SONY® Service Bulletin

NO: HIF12-99-012

SUBJECT: ERROR MESSAGE "C-13 DISC ERROR" WHEN USING A NEW DISC

MODEL (S): MDS-JB920/JE520

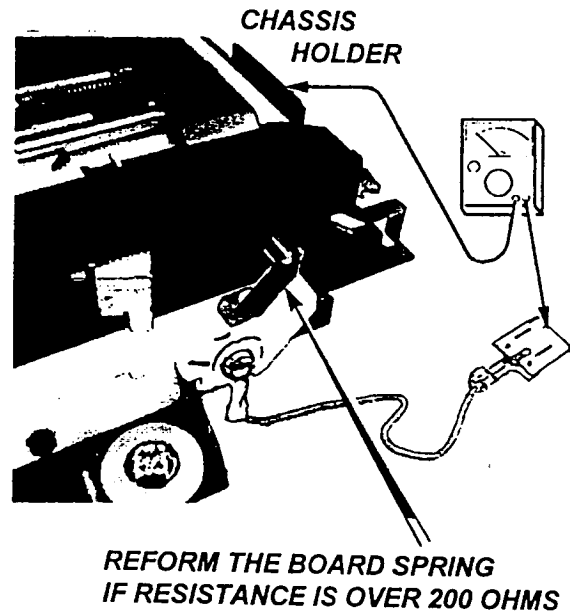
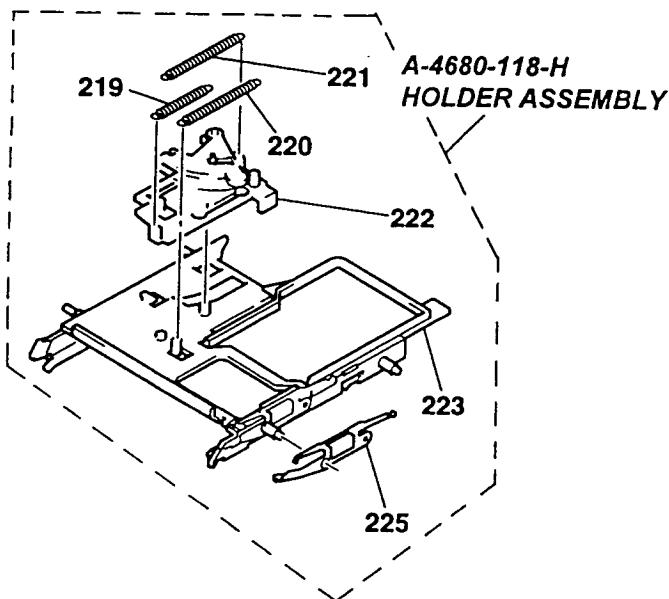
SYMPTOM: The customer complaint states the unit displays error message "C-13 Disc Error" when using a new disc.

SOLUTION: Replace the holder assy P/N (A-4680-118-H). After replacing the holder assembly test the continuity between the chassis at the holder Assy and the main board ground. (must be less than 200 ohms). If continuity reading is higher than 200 ohms reform the board spring (see picture).
